Subject: FW: Draft EIR Comment on Proposed Bob Jones Bike Path SLO to Ontario Road Project

RESPONSE TO LETTER 17B – TERRY N. TAYLOR

2.3 RESPONSE TO SPECIFIC COMMENT LETTERS ON THE RDEIR

RESPONSE TO LETTER RD-A – CALIFORNIA DEPARTMENT OF TRANSPORTATION (CALTRANS)

Figure 3.0-3a
Baron Canyon Bridge Detail (Option A)

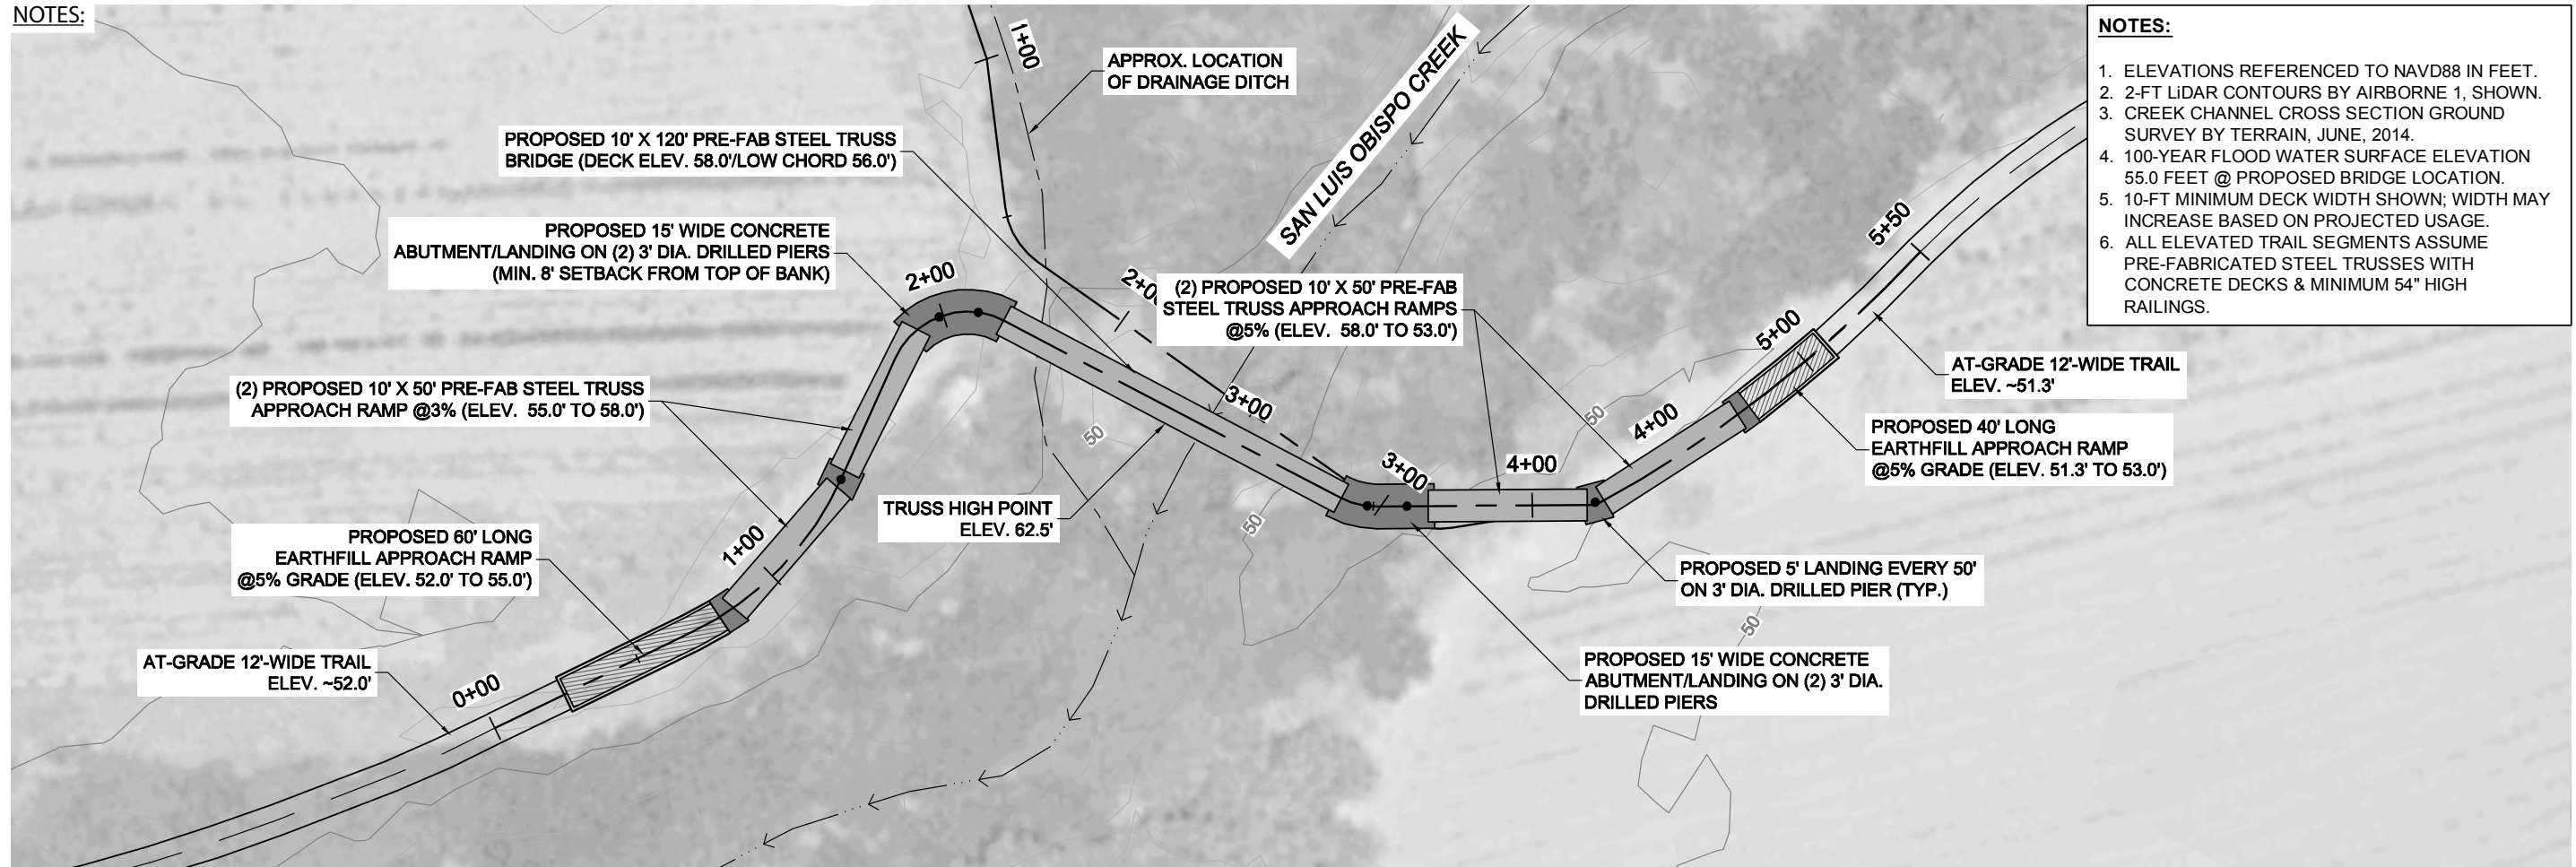
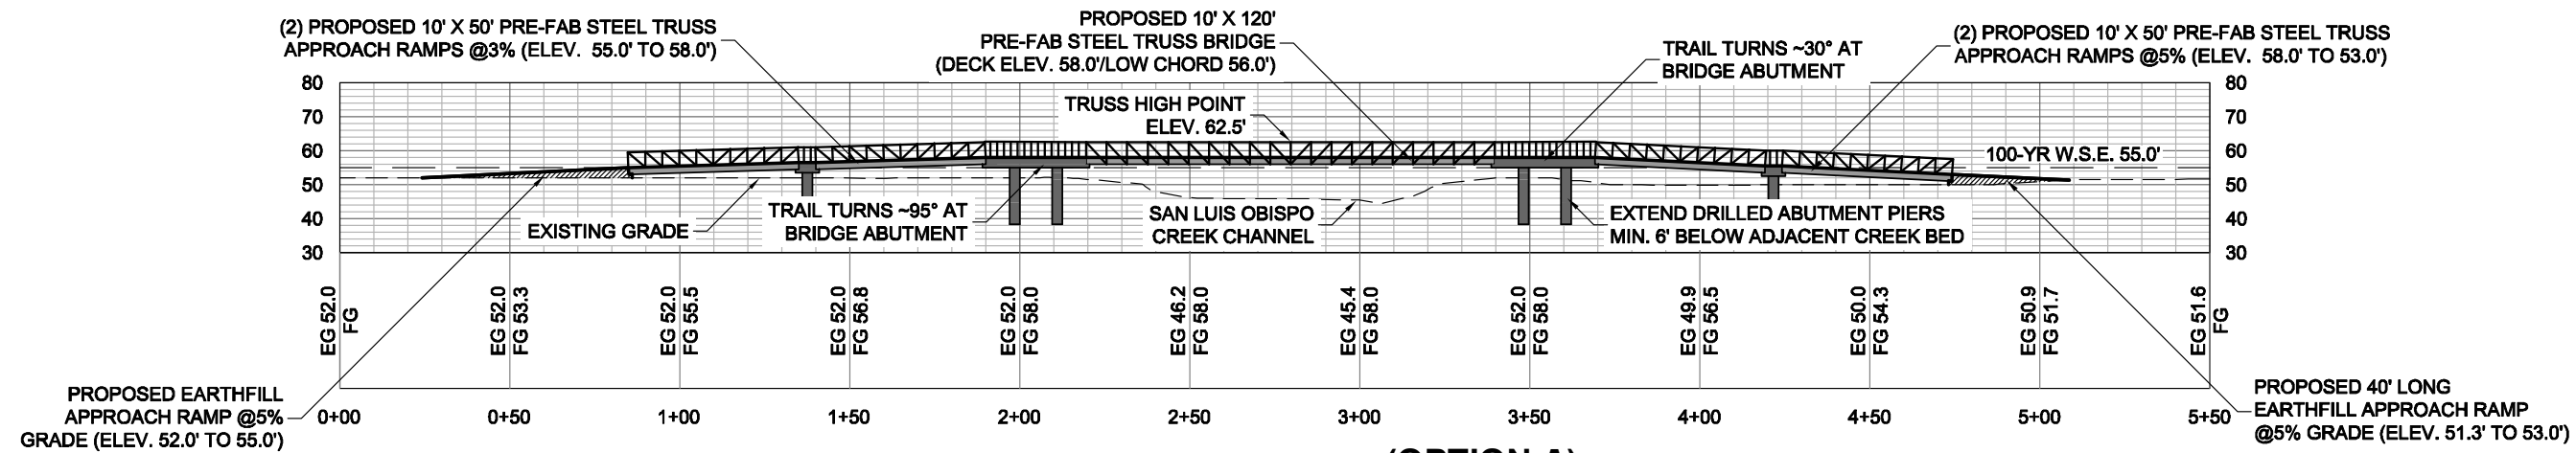
RDEIR Figures 3.0-3a and 3.0-3b have been updated and attached to correct minor labeling errors.
